**ENERGY EFFICIENCY EVALUATION OF THE
HOUSING COMMUNITY PLAN DEVELOPED FOR
SHAW AIR FORCE BASE**

May 1992

Prepared for the
Civil Engineering Squadron
Shaw Air Force Base, South Carolina

Fig. 2.1. Disconnected supply ducts as found in the attic of unit 4055A.

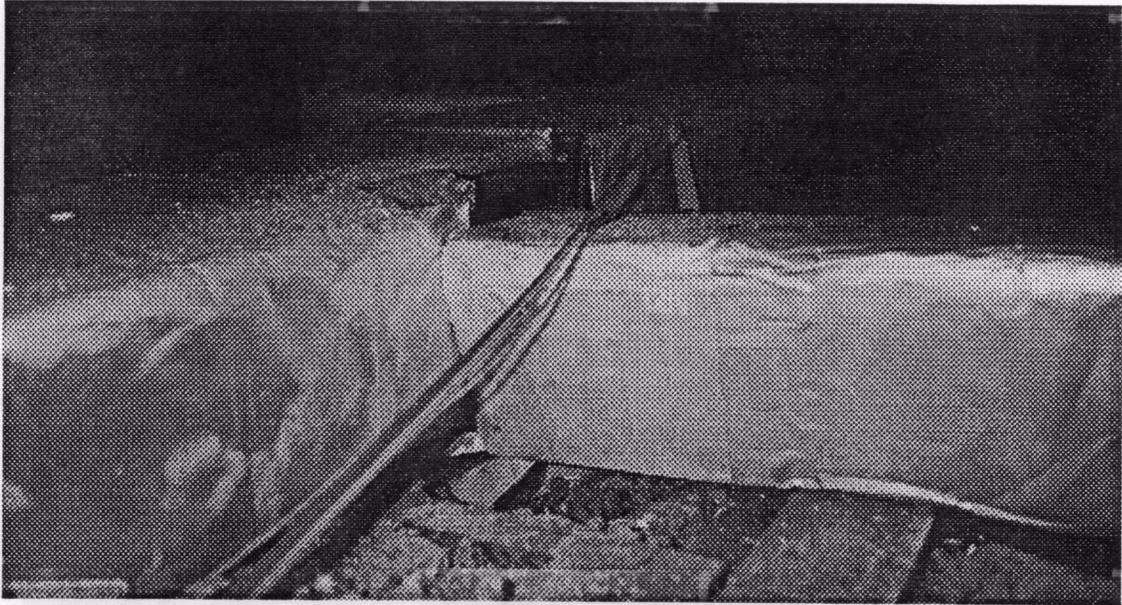
Inspection of the air-distribution systems revealed significant problems in each unit. In unit 4055A (the single-story unit), the distribution system located in the attic was disconnected in several places (see Figs. 2.1a-c). It appeared that duct tape used to attach sections of the rigid duct board lost adhesion. Ducts leading to outlet registers were offset several inches from the main supply duct, leaving physical separations big enough to put one's hand through. Sections of the main supply duct had also shifted from each other, leaving similar size openings. Walking boards placed along the main supply ducts indicated a significant level of work had been performed in the attic; perhaps this work hastened the separation of the ductwork (a ridge vent was added to the roof, although this by itself should not have impacted the distribution system).

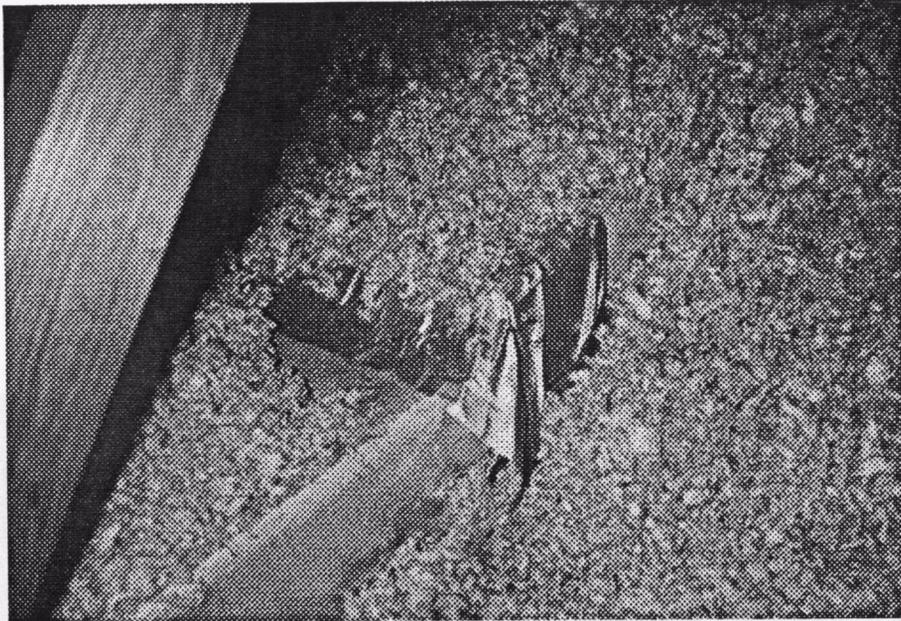
In unit 4073B (the two-story unit), leaks in the supply and return ducts located in the outdoor equipment room were readily apparent using a smoke pencil and with the distribution fan running (see Fig. 2.2). The return leaks caused unconditioned air from the equipment room to be drawn into the distribution system. Because the gas furnace and gas water heater were located in this room, the return leaks could cause flue gases to backdraft and enter the unit. The supply leaks were located in the housing unit, causing air to be blown out the crack around the supply duct where it penetrated the building shell. As shown in Fig. 2.3, duct tape sealing a joint in the supply duct located in the attic was beginning to peel away, creating a supply leak.

Fig. 2.6. Loose fill insulation in the attic of unit 4073B had been blown away from the edge, leaving a portion of the attic floor uninsulated.

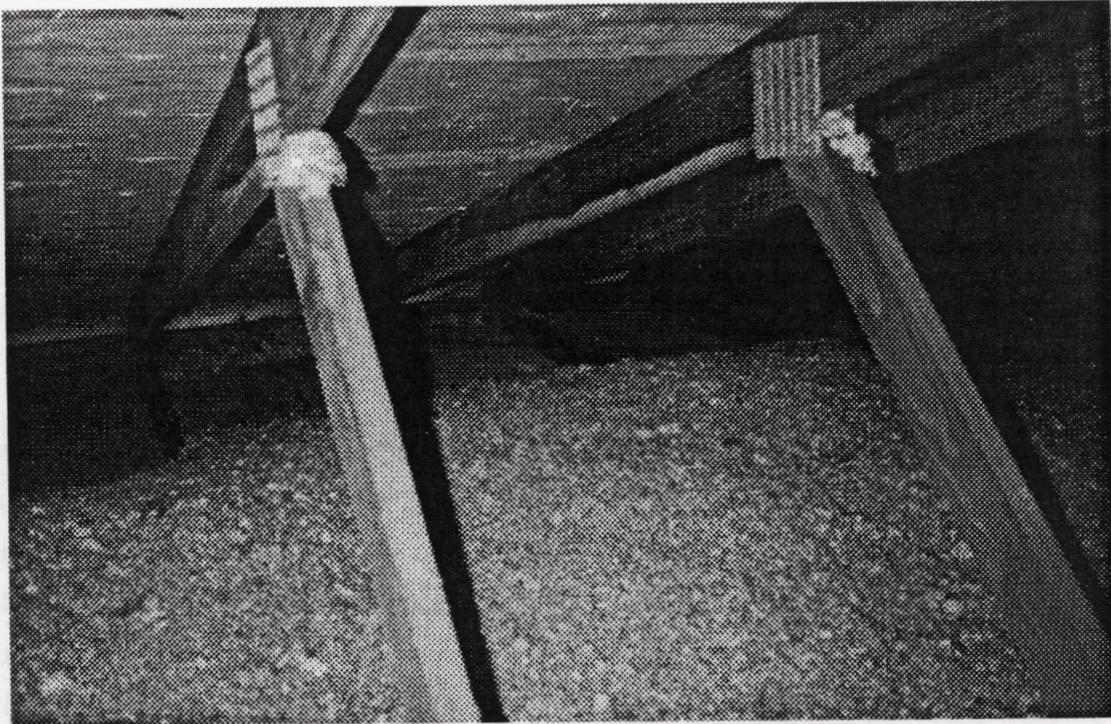
Several problems with the insulation installed in unit 4073B were found. As shown in Fig. 2.6, loose fill attic insulation had been blown into the middle of the attic, leaving the attic floor six feet from the front of the unit uninsulated. This may have occurred due to high winds generated from hurricane Hugo. Both the front and rear second-story overhangs had no floor insulation; these floors were directly exposed to ambient conditions and were likely leaky. The attic floor under and around the attic supply ducts was not always insulated. The insulating blanket installed on the water heater was falling off, rendering it ineffective (Fig. 2.7).

- Inspection of existing soffit vents needs to be added to the specifications to ensure that they are not covered by insulation or debris, that screening still exists, and that there is 1.0 ft² of free ventilation area for each 300 ft² of attic area. Any deficiencies need to be corrected.
- The use of soffit "dams" needs to be included in the specifications to ensure that soffit vents do not become covered by insulation or other debris in the future.
- Use of light-colored roof shingles needs to be included in the specifications to extend shingle life and reduce cooling loads.
- Inspection of existing attic insulation needs to be added to the specifications. The main problems to look for are lack of sufficient insulation (R-30) and insulation that does not evenly cover the entire attic, especially at the edges and under ducts. Any deficiencies need to be corrected.

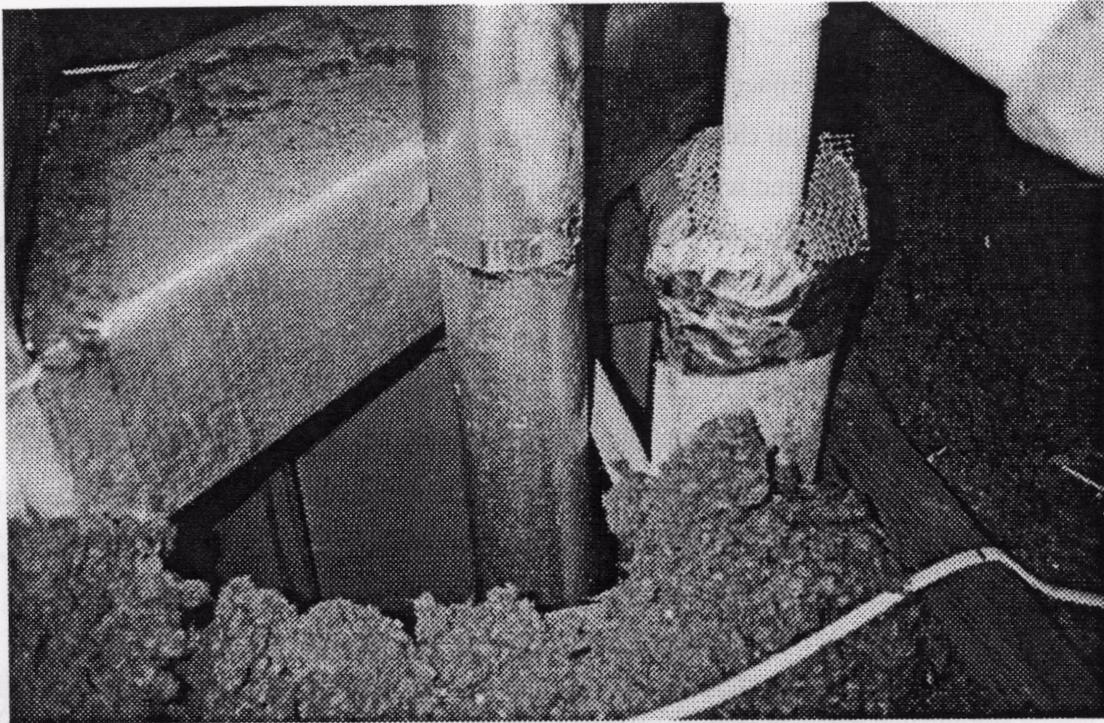
- A passageway (Fig. 2.8) allowed the gas furnace flue, combustion-air pipes, and supply duct to extend through the second story of the unit to the attic. This passageway was not sealed at the attic. A similar bypass was also found in unit 5429B.
- With the installation of the condensing furnace, a plastic flue pipe (with about a 2.5-inch diameter) was installed. The new flue was run inside the previous flue pipe (with about a 6-inch diameter) to the attic and out the roof, but the space between pipes was not sealed at either end (see Figs. 2.8 and 2.9).
- A pipe (with about a 6-inch diameter) was installed between the attic and interior equipment room to provide combustion air to the gas furnace (see Fig. 2.9). As discussed in Sect. 2.2, this pipe served as an attic bypass when the furnace was not operating.

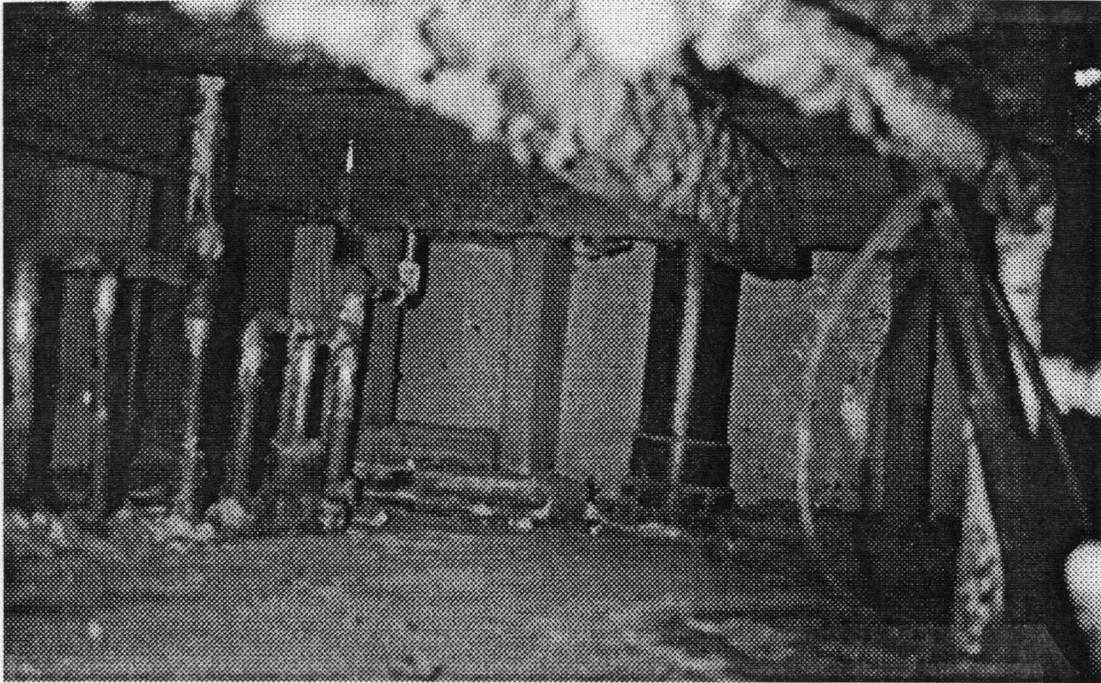
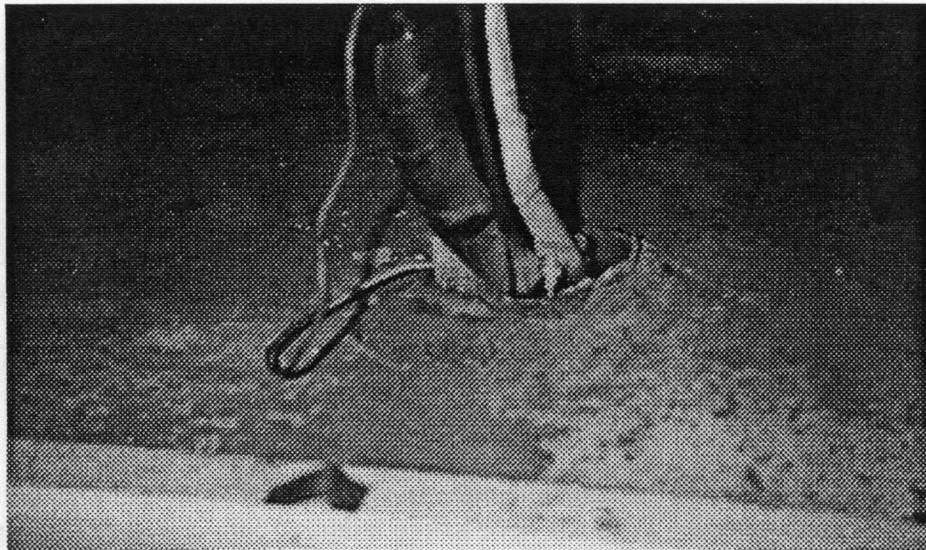
- The return plenum of each unit was connected to the attic and/or outside by the interior walls used to form the plenum, gaps around plumbing running through the plenum, and a pipe used to run refrigerant and condensate lines outside to the condensing unit (see Figs. 2.11a-b). Operation of the distribution fan (which

reduces the pressure in the return plenum 15 Pa below house pressure) drew significant amounts of attic or outside air into the return air stream. Interior partition walls were used to form the plenum. These walls had drywall or paneling on the side that faced living spaces; however, no drywall was installed on the plenum side of the studs. A major drain line from the second floor ran down one of the cavities formed between the studs. During the blower-door testing, air flow was readily evident coming down the wall cavities and from around the drain pipe, indicating that the cavities were open at the top and connected to the space between floors, which was subsequently connected to the attic or outside. A plastic pipe (with about a 4-inch diameter) was run under the slab of the unit and contained the refrigerant and condensate lines. Because this pipe was not sealed at either end, it directly connected the return plenum to the outside.

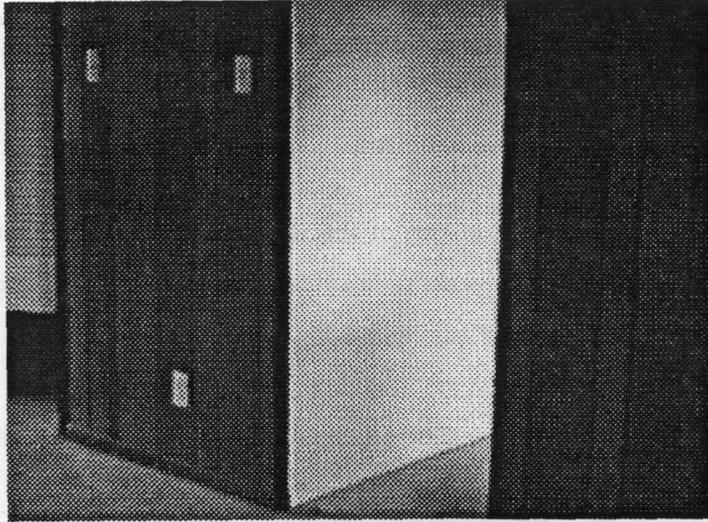
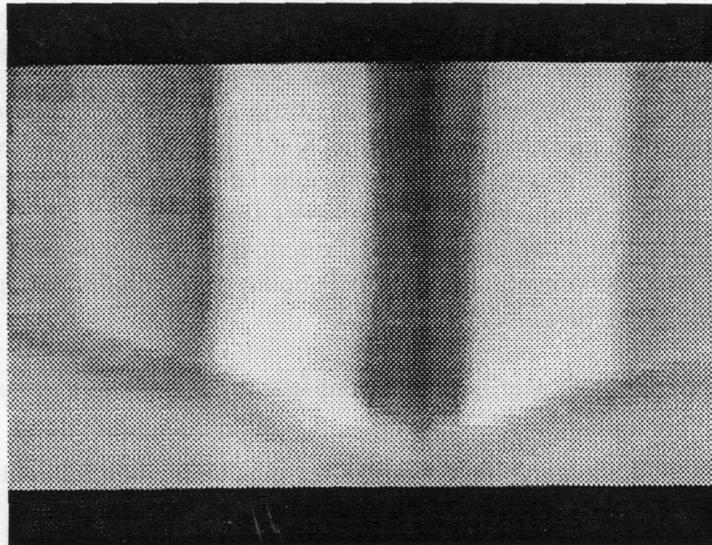
- Conditioned air recirculated directly back to the return plenum in the two units because of the open wall cavities described above. The condensing furnace was an upflow model with an A-coil installed on top. Conditioned air exiting the A-coil directly entered a small supply plenum above it. Ducts then directed conditioned air from the supply plenum to outlet registers. The supply plenum was formed using two of the same interior walls as the return plenum. One cavity in each of these walls was open in the supply plenum (there was no drywall on the plenum side of the wall studs), allowing air to circulate from the supply plenum, down the wall cavity, and into the return plenum. Photographs taken with an infrared camera demonstrate this in Fig. 2.12.
- Air filters in both units were very dirty.
